### Public Comments on the Draft GSP on Dec 11 2021

**Re: Public Comment Letter for Turlock Subbasin Draft GSP**

## Specific Comments on the Turlock Subbasin Draft Groundwater Sustainability Plan

**Re: Comments on the Turlock Subbasin Groundwater Sustainability Plan (GSP).**

**Figure 2A - Estimated Water Level Change at Measurable Objectives and Domestic Wells  
West and East Turlock Subbasin GSA**

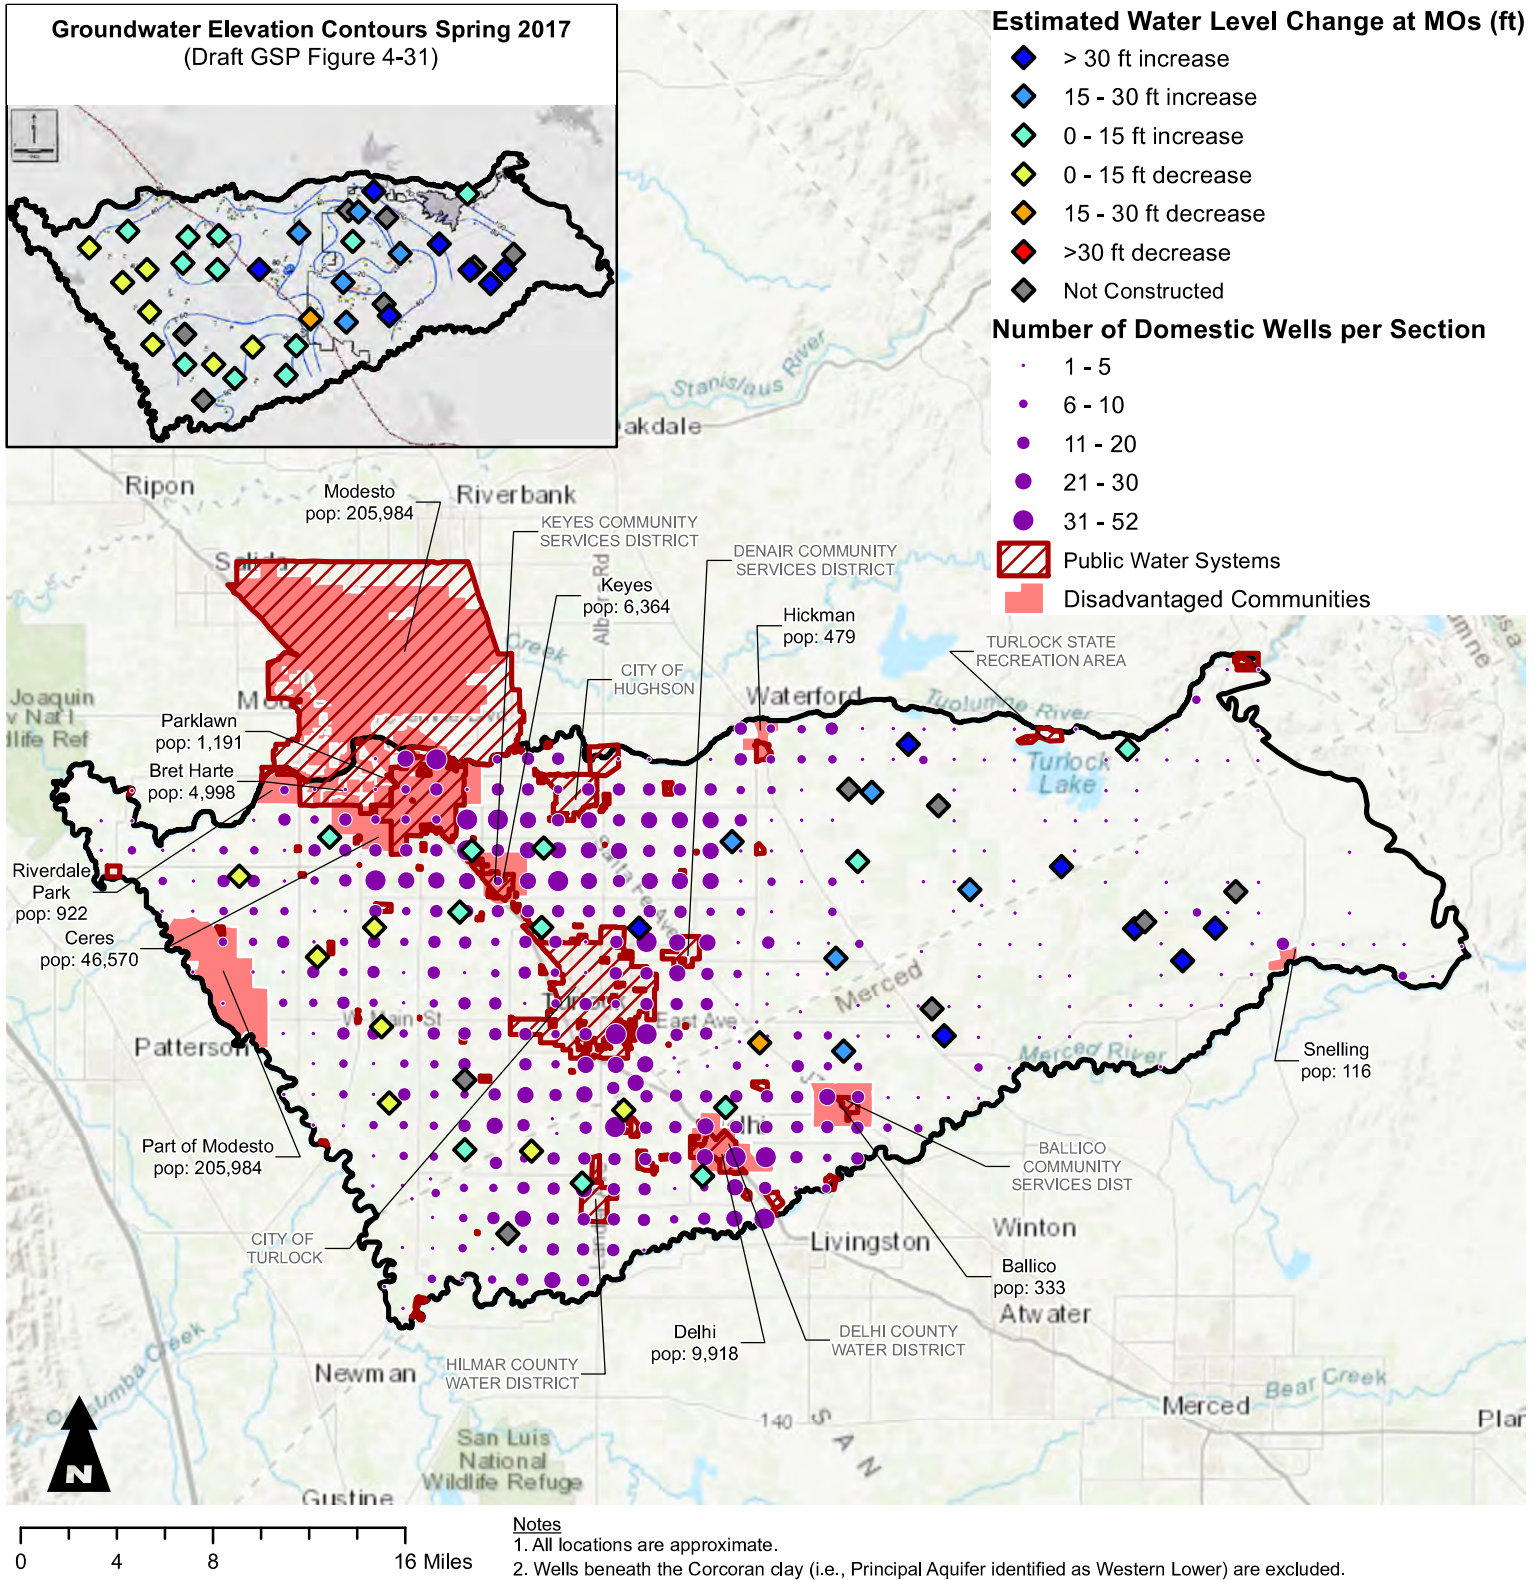
- **Figures 2A and 2B** show the approximate locations of domestic wells and water level RMWs within the Subbasin. For each RMW, the change in water level from current conditions (i.e., the most recent water level measurement reported in the hydrographs presented in the draft GSP Appendix X), that will occur if water levels reach the MOs and MTs were calculated. Based on this, if water levels reach the MOs, this will result in an increase in water levels in the eastern portion of the Subbasin (up to 62 feet higher), and a decline in water levels in the western portion of the Subbasin (up to 21 feet lower). If water levels reach the MTs, water levels across the majority of the basin will decline, by up to 38 feet. The draft GSP makes several unsupported assertions that domestic wells will not be further impacted if water levels reach MTs, but does not include an actual analysis of this, by comparing available domestic well depth data to the anticipated water level declines. The draft GSP also does not address how many domestic wells will be affected if water levels in areas of 33% of the RMWs are allowed to decline below MTs for a three year period before triggering an undesirable result. **The GSP should present a thorough, robust, and transparent analysis, supported by maps, that identifies: 1) which domestic wells are likely to be impacted at the MTs and at the MOs, and 2) the location of the likely impacted wells with respect to DACs and other communities and systems dependent on groundwater.**

- **Figures 2A and 2B** show current (Spring 2017) groundwater elevation contours for the Subbasin, alongside the change in water level depths to reach the MOs and MTs, respectively. As illustrated in **Figure 2A and 2B**, given that the change in groundwater elevation to reach MOs and MTs varies significantly between RMWs, groundwater flow gradients would be expected to change as MOs and MTs are reached. However, the draft GSP does not include an analysis of these gradients (i.e., presenting contour maps of groundwater elevations at MOs and MTs). Section 6.3.2 says “These MTs allow GSAs to manage to an existing groundwater surface throughout the Subbasin, demonstrating that hydraulic gradients associated with the MTs can be supported by the Principal Aquifer systems;” however, the draft GSP does not provide any further analysis or explanation to support this statement. Further, this analysis is key to demonstrating “How minimum thresholds have been selected to avoid causing undesirable results in adjacent basins or affecting the ability of
